Area Walk-By Checklists (AWCs)

Table D-1. Summary of Area Walk-By Checklists

IMG_1143

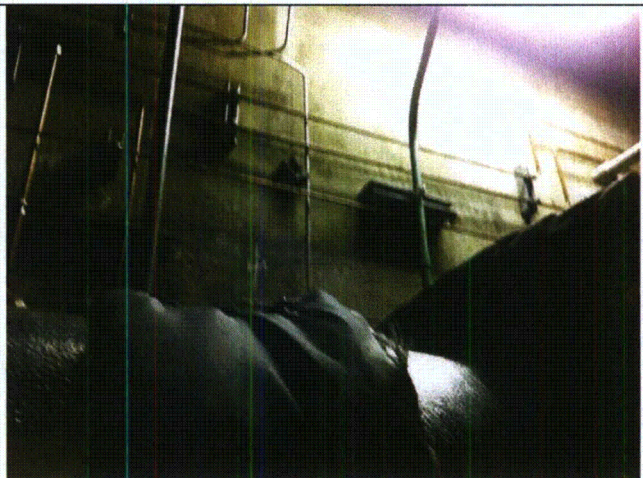
Instrument line FW-V-1073 second clamp not attached. Middle clamp misaligned. IR 1400290 - LOOSE/MISALIGNED MOUNTING CLAMP ON FW INSTRUMENT LINE addressed this. The Valve is a failed closed valve, therefore not a seismic concern.

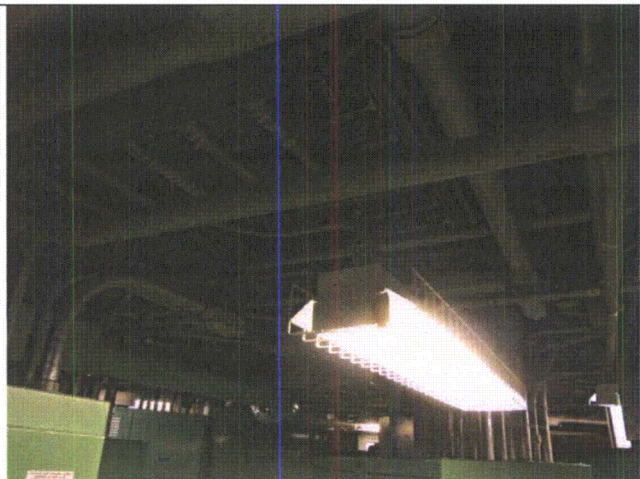
Overhead light in the vicinity of XCLA has S-Hooks that need to be crimped closed. This is not a seismic interaction issue because there is no equipment below the light. This issue is generically addressed by IR 1401692.

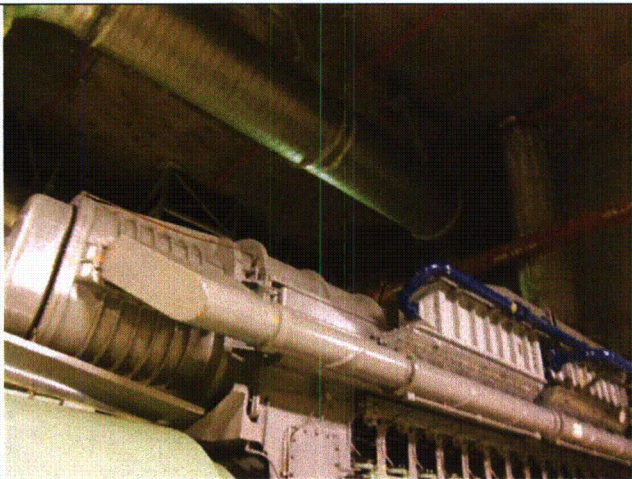
Chipped paint on diesel pad

Surface spalling on South Wall is previously documented under Maintenance Rule Inspection R2151812. R2151812 tracks completion of the walkdown and updates the topical report with its results.
